Northrop Grumman Response to HDR Report for Bethpage Plume Executive Summary - December 5, 2016

The New York State Department of Environmental Conservation (Department) directed Henningson, Durham & Richardson Architecture and Engineering, P.C. (HDR) to evaluate remedial options for addressing the groundwater plume associated with the Grumman Aerospace and associated U.S. Navy Bethpage Facilities ("Bethpage plume"). The July 2016 "HDR Report" provides the Department with three groundwater remedial options to consider:

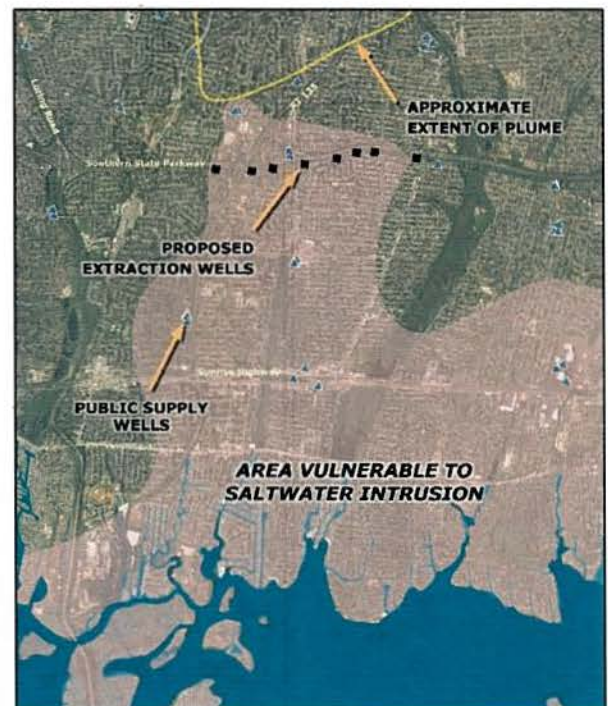
The extensive pumping the remedial options call for would lower the groundwater water levels and exacerbate saltwater intrusion. Supply wells lying within the 5-foot water level contour such as Massapequa Water District wells, would be particularly vulnerable to saltwater intrusion, as indicated in the figure on the right. In most cases, aquifers impacted by saltwater are lost to beneficial use and supply wells contaminated by saltwater are abandoned or used sparingly. The affected water districts would then be forced to meet the needs of their customers by providing water from other sources.

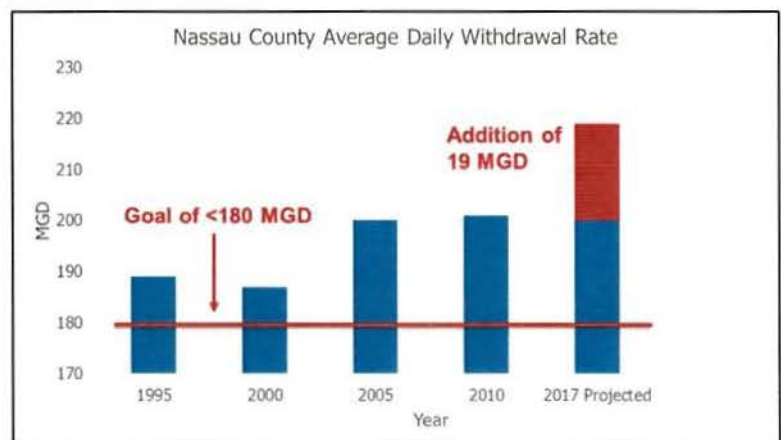
Massapequa Creek and Massapequa Preserve are areas of important and limited natural habitat in Nassau County. One of the remedial options, Option 1, requires 19 MGD of treated groundwater to be discharged to the Massapequa Creek, increasing its average flow fivefold. This increased water flow would intensify erosion and sedimentation, which would change the stream's ecology and threaten the elimination of local populations of rare and endangered plants. Under Options 2 and 3, groundwater flow into Massapequa Creek would be severely reduced, which would alter important habitats such as the wet pine barrens in the Massapequa Preserve and further harm threatened and endangered species. Also, reduction in water flow would impair the use of the preserve for bird watching, hiking, and recreational fishing.
